AN ORDINANCE OF THE CITY OF SEAGOVILLE, TEXAS

ORDINANCE NO. 13-2019

AN ORDINANCE OF THE CITY OF SEAGOVILLE, TEXAS, AMENDING THE CODE OF ORDINANCES BY AMENDING CHAPTER 21, ARTICLE 21.02, DIVISION 3, RESIDENTIAL CODE, SECTIONS 21.02.101 AND 21.02.102 TO PROVIDE FOR THE ADOPTION OF THE INTERNATIONAL RESIDENTIAL CODE FOR ONE- AND TWO-FAMILY DWELLINGS, 2018 EDITION AND AMENDMENTS THERETO; PROVIDING A PENALTY OF FINE NOT TO EXCEED TWO THOUSAND DOLLARS (\$2,000.00); PROVIDING FOR SEVERABILITY; PROVIDING A SAVINGS CLAUSE; PROVIDING A REPEALING CLAUSE; AND PROVIDING FOR AN EFFECTIVE DATE.

Figure R602.6.1; delete the figure and insert the following figure:

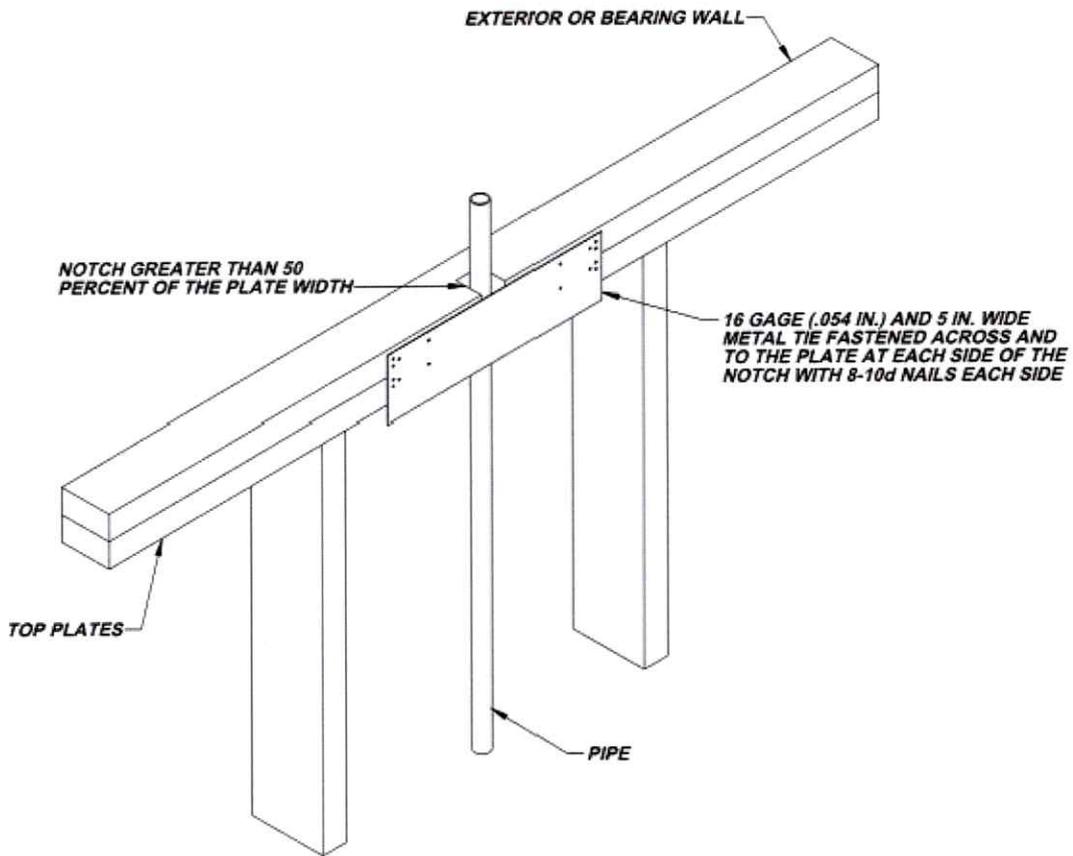
Section R602.6.1; amend as follows:

R602.6.1 Drilling and notching of top plate. When piping or ... *{bulk of paragraph unchanged}* ... than 50 percent of its width shall be required to have a 2x6 wall and a galvanized metal tie not less than 0.054-inch thick (1.37 mm) (16 ga) and ~~4-1/2-5~~-inches (~~38~~ 127 mm) wide shall be fastened across and to the plate at each side of the opening with not less than eight 10d (0.148-inch diameter) nails having a minimum length of 1-1/2 inches (38 mm) at each side or equivalent. Fasteners shall be offset to prevent splitting of the top plate material. The metal tie must extend ~~not less than~~ a minimum of 6-inches (152 mm) past the opening. See Figure R602.6.1. *{exception unchanged}*
